SUBJECT: SPECIAL SERVICE CAMPAIGN (SSC) – 50L
2004 THROUGH MID-2005 MY SIENNA MIDDLE ROW SEATBELT BEZEL

SPECIAL SERVICE CAMPAIGN 50L

2004 THROUGH 2005 MODEL YEAR SIENNA
MIDDLE ROW SEATBELT BEZEL

IV. COMPONENTS

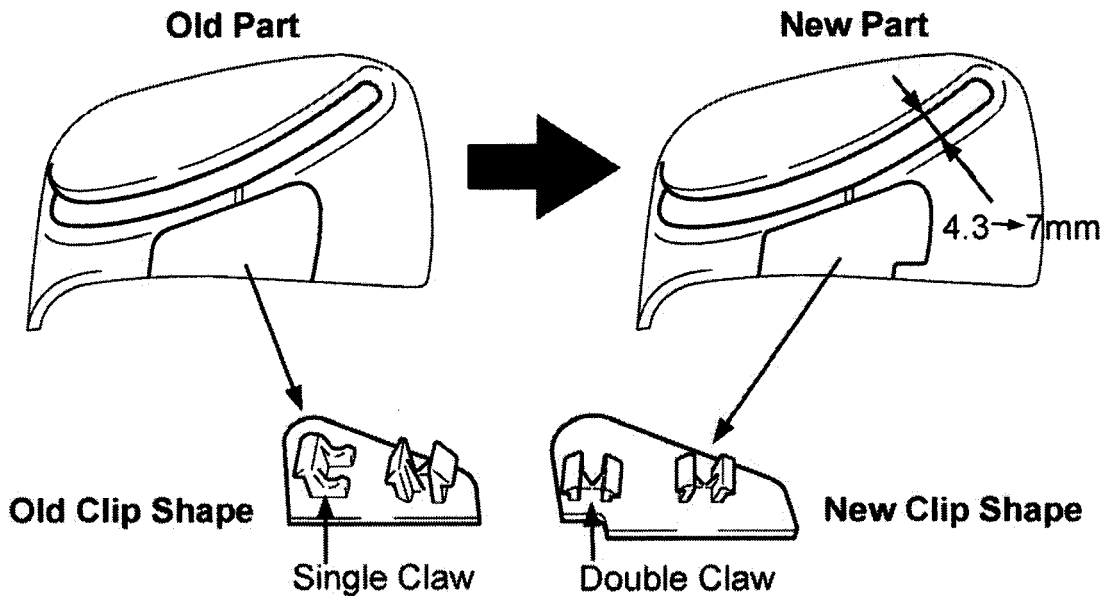
*On 7-passenger models the seatbelt bezel is located on the RIGHT seat assembly
On 8-passenger models the seatbelt bezel is located on the CENTER seat assembly*

1. REMOVE THE MIDDLE ROW SEATBELT BEZEL

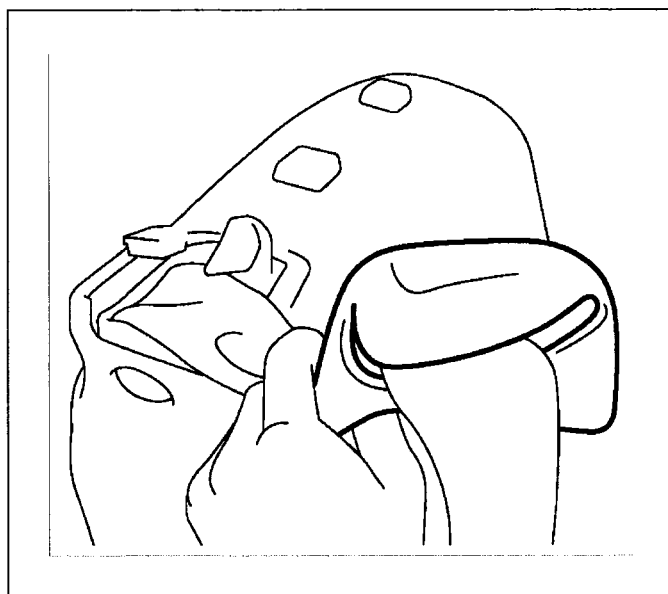
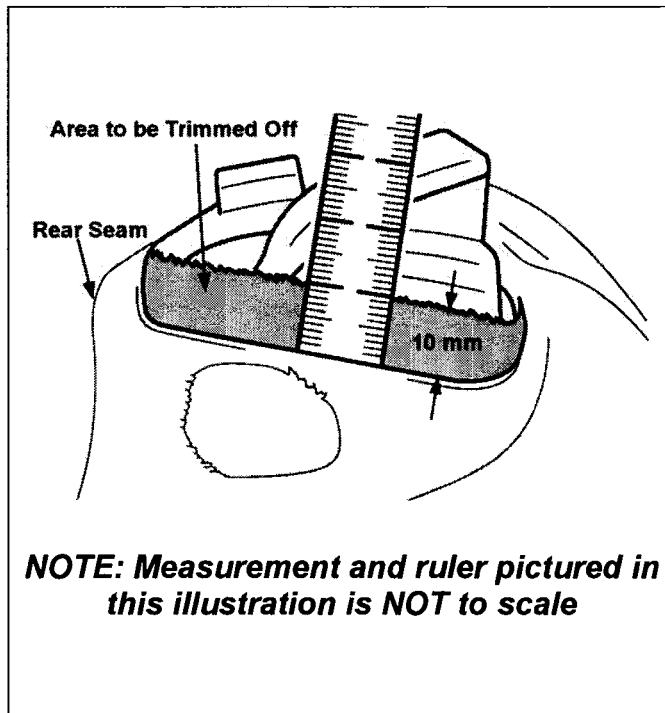
- (a) Remove the headrest
- (b) Remove the side clip.
- (c) Remove the screw.
- (d) Using the nylon pry tools, disengage the claws for the front clip.
- (e) Apply firm pressure to the back side of the seatbelt bezel where the claw is located. While applying pressure to this area push up to disengage the seatbelt bezel from the claw.
- (f) Remove the seatbelt bezel from the seat.
- (g) Remove the seatbelt from the seatbelt bezel by sliding it through the slit.

2. TRIM THE SEATBACK COVER

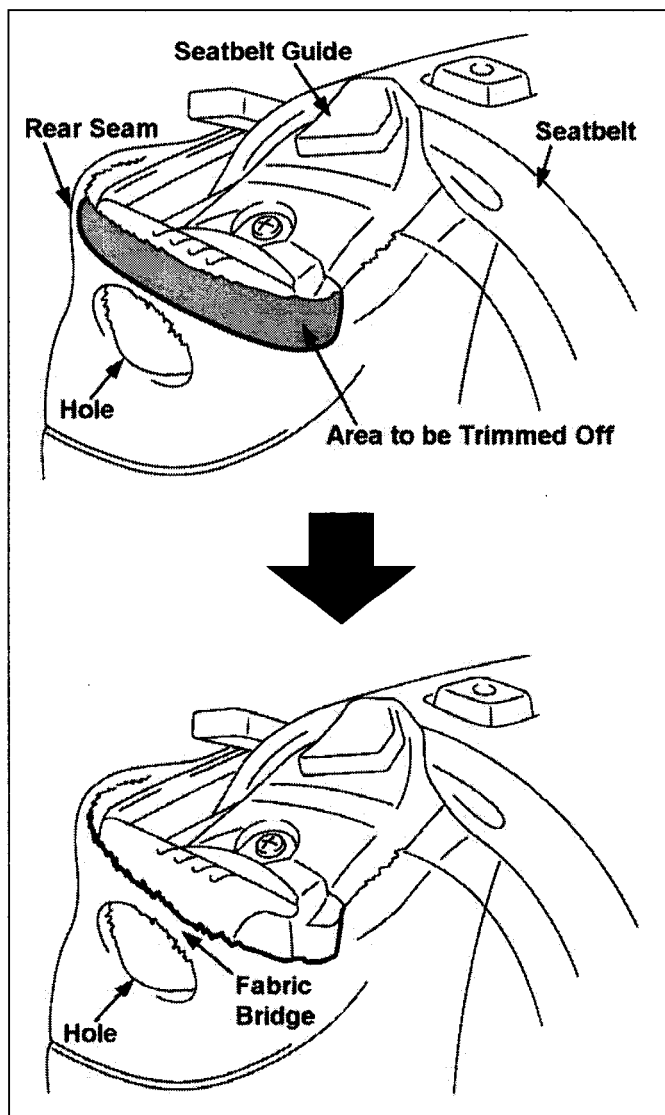
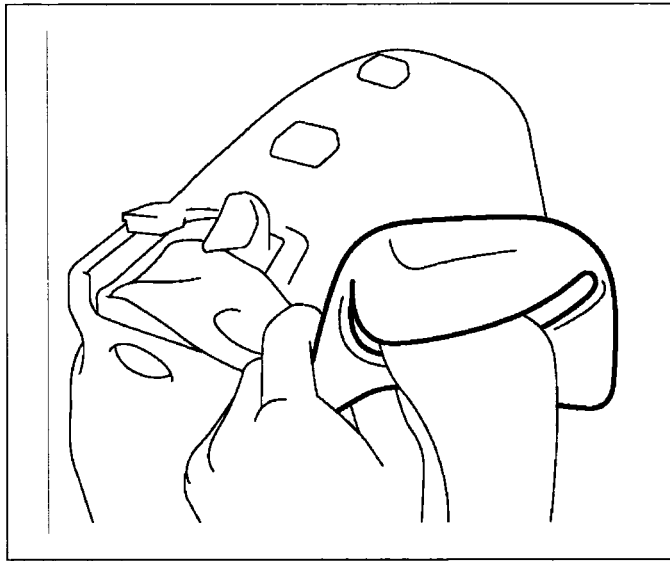
To prevent the edge of the seat material from being visible through the seatbelt slot on the new seatbelt bezel, a small portion of the seat cover must be trimmed.

(a) Measure 10 mm down from the upper edge of the seatback cover (as shown in the illustration), and draw a horizontal line from the front corner to the back edge of the seatback cover, just before the rear seam.

(c) Using a pair of scissors, **CAREFULLY** cut along the line drawn, trimming off the shaded portion of the seatback cover **ONLY**. During this process make sure to maintain a fabric bridge between the seat back cover hole and area to be trimmed off.

- DO NOT cut any portion of the rear seam located on the back edge of the seatback cover.
- DO NOT cut more than this amount.
- USE EXTREME CAUTION when cutting.

3. INSTALL THE NEW MIDDLE ROW SEATBELT BEZEL

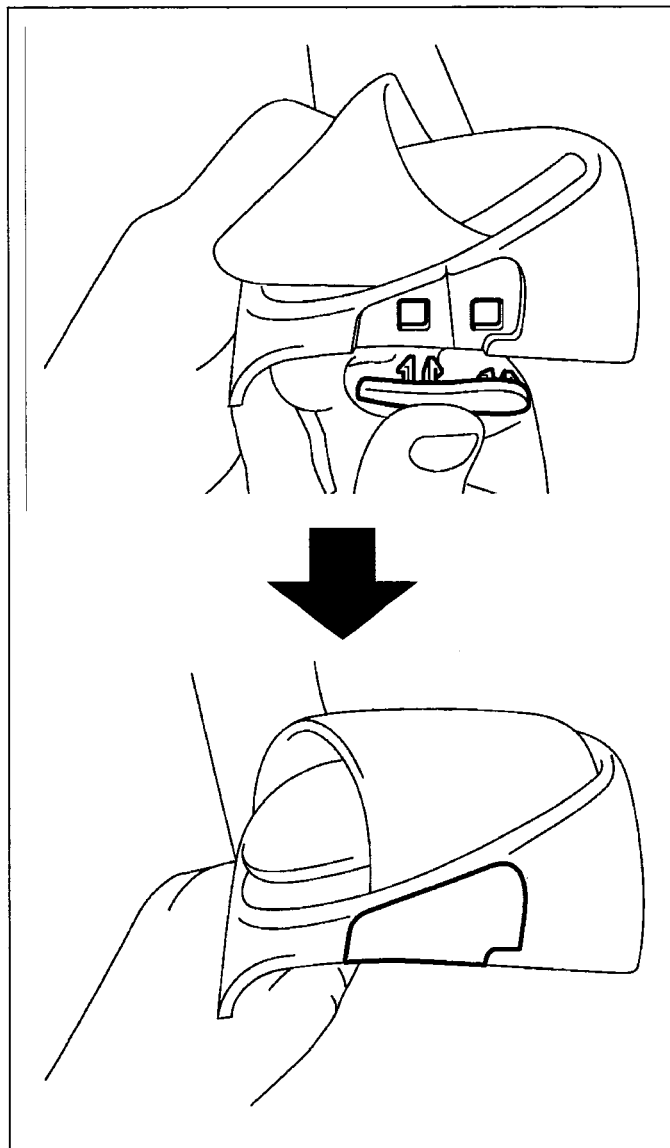
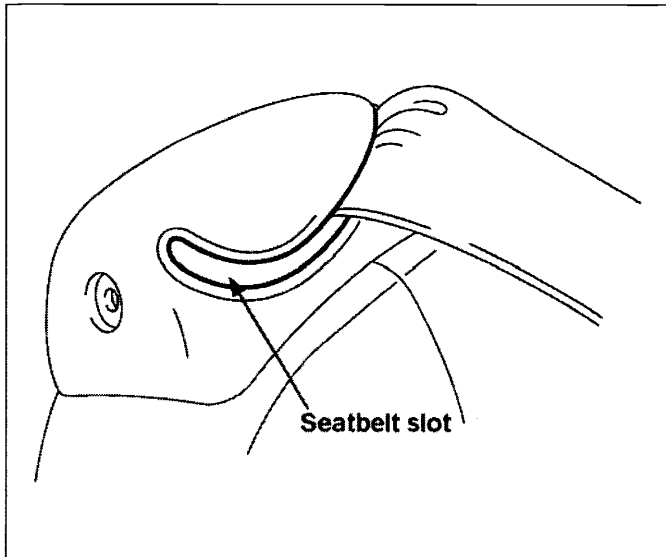
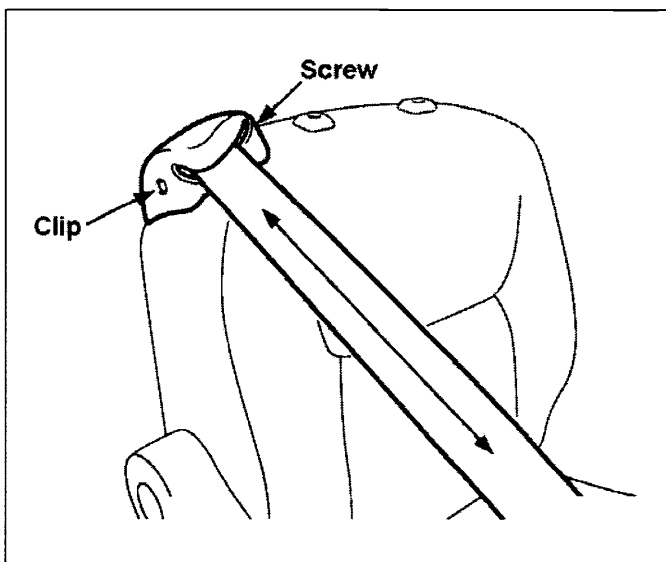
(a) Install the seatbelt to the new seatbelt bezel by sliding it through the slit.

(b) Install the new front clip.

(c) Confirm that all 4 claws are engaged.

- (d) Install the new seatbelt bezel.
- (e) Press down on the seatbelt bezel until the back side claw engages.
- (f) Move the seatbelt to the side as shown in the illustration, and check that the seat cover material cannot be seen through the seatbelt bezel slot.

- (g) Reinstall the screw.
- (h) Reinstall the side clip.
- (i) Reinstall the headrest.
- (j) Confirm that the seatbelt retracts properly.
